Proposal for an amendment of paragraph 1.1. in Annex 10 of UN Regulation No. 13 (Braking regulation)

The text reproduced below was prepared by the expert from the European Association of Automotive Suppliers (CLEPA) to resolve the problem of decreasing trailer brake performance caused by brake pads and linings “falling asleep”. The modifications to the existing text of the Regulation are marked in **bold** for new and ~~striketrough~~ for deleted characters.

Diagram 2
Towing vehicles and trailers
(except tractors for semi-trailers and semi-trailers and full trailers)
(see paragraph 3.1.5.1. of this annex)

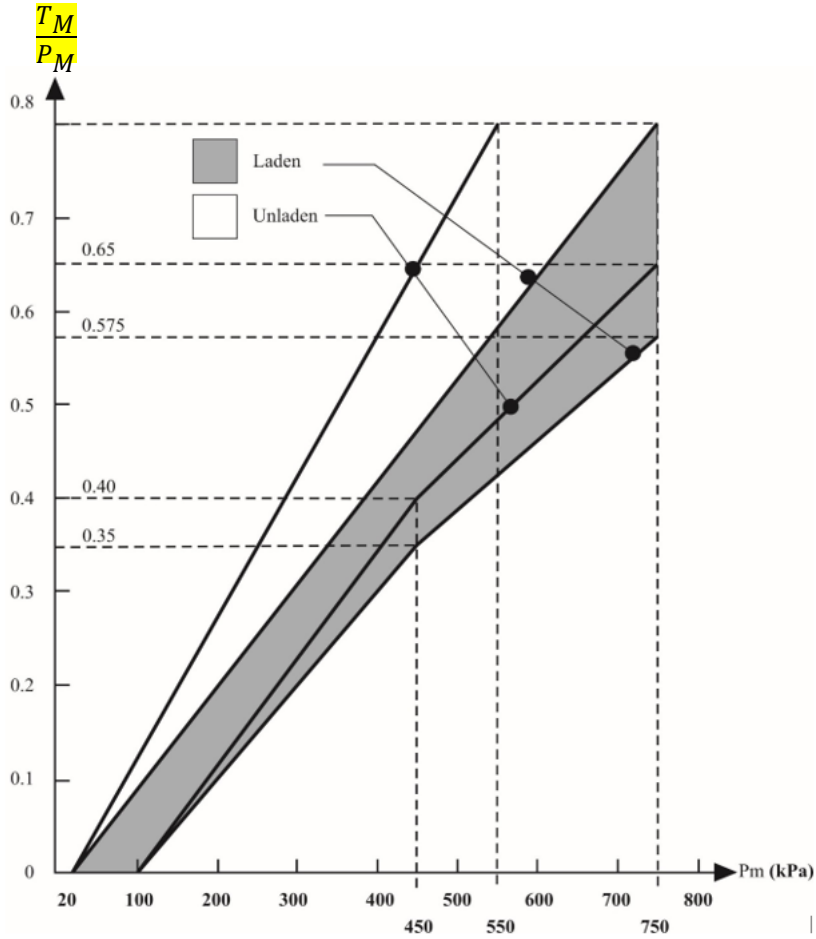
Annex 10, Diagram 2 and Diagram 4A . amend to read:

Diagram 4A
Semi-trailers
(see paragraph 4. of this annex)

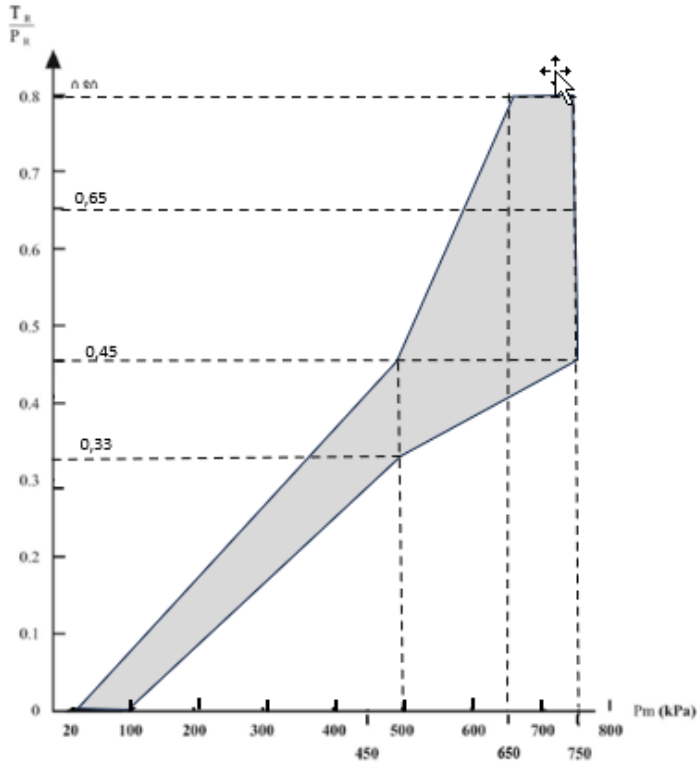
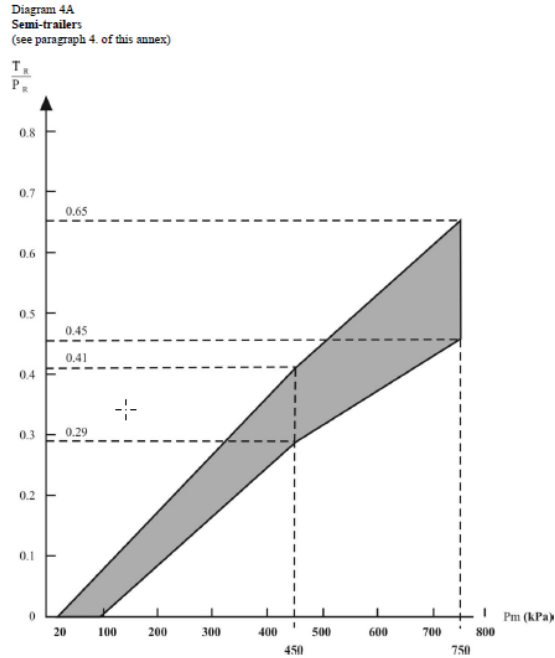
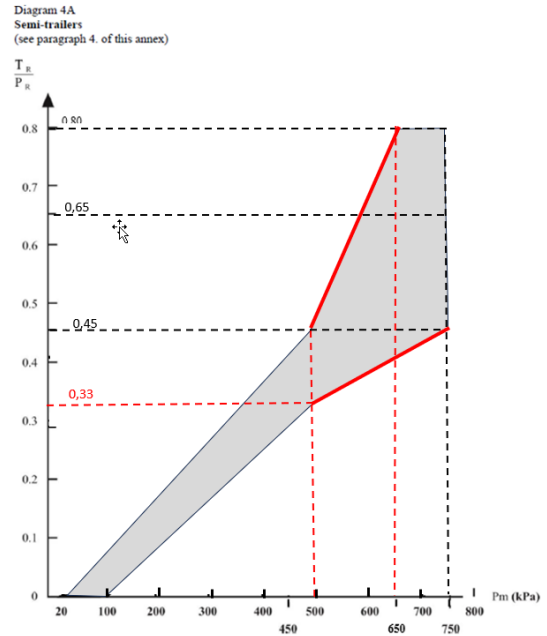
On the other hand, the maximum brake force which may be installed in trailers is limited by the upper line of the compatibility band as currently shown in diagrams 2 (for truck and full-trailer) and 4A (for semi-trailer) of Annex 10.

Extension of the compatibility bands at higher control pressure ($p_m \geq 500$ kPa) by modification of diagram 4A for semitrailers and adding a new diagram 5 for full trailers instead of using diagram 2 for towing vehicles. This allows to install stronger brakes with higher brake forces and higher safety margin to compensate for the possible loss of brake performance as described above. With $p_m < 500$ kPa the same characteristic as of today will ensure brake compatibility for harmonization of brake forces between towing vehicle and trailer. Higher brake force can be realized e.g. by using next size of brake chambers (e.g. 20” brake chamber instead of 16” which results in 25% brake force increase).

Changings marked in red

Diagram 5
Full trailers and centre-axle trailers
(see paragraph 5 of this annex)

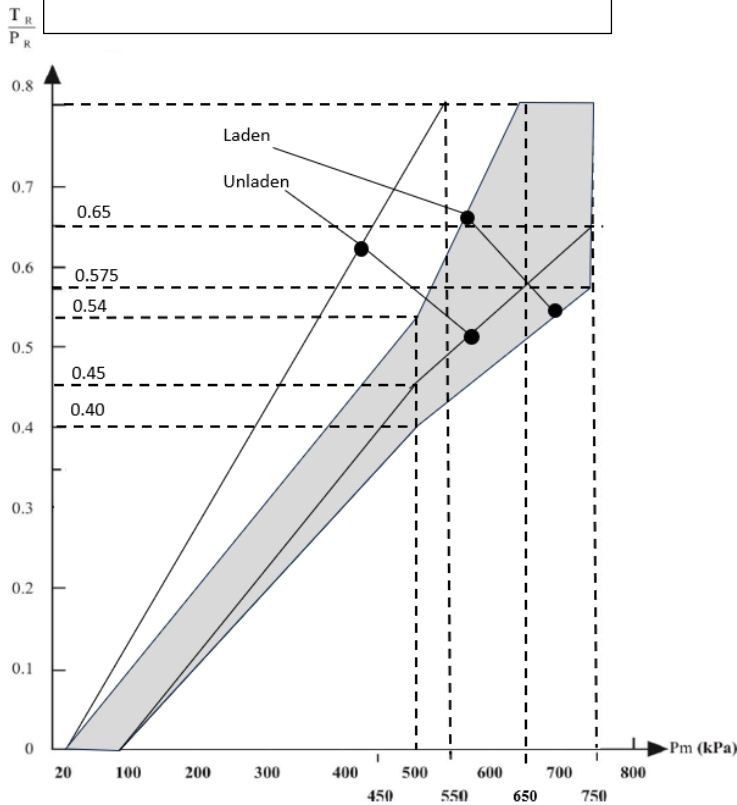
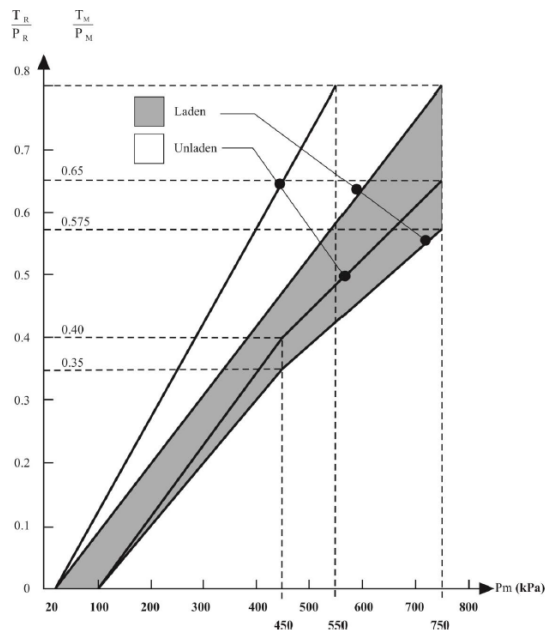
Annex 10, add a new diagram 5

- 5.1.3. The permissible relationship between the braking rate T_R/P_R and the pressure p_m shall lie within the designated areas in diagram **2 5** of this annex for all pressures between 20 and 750 kPa, in both the laden and unladen states of load.

- 5.2.1. The permissible relationship between the braking rate T_R/P_R and the pressure p_m shall lie within two areas derived from diagram **2 5** of this annex, by multiplying the vertical scale by 0.95. This requirement shall be met at all pressures between 20 and 750 kPa, in both the laden and unladen states of load.
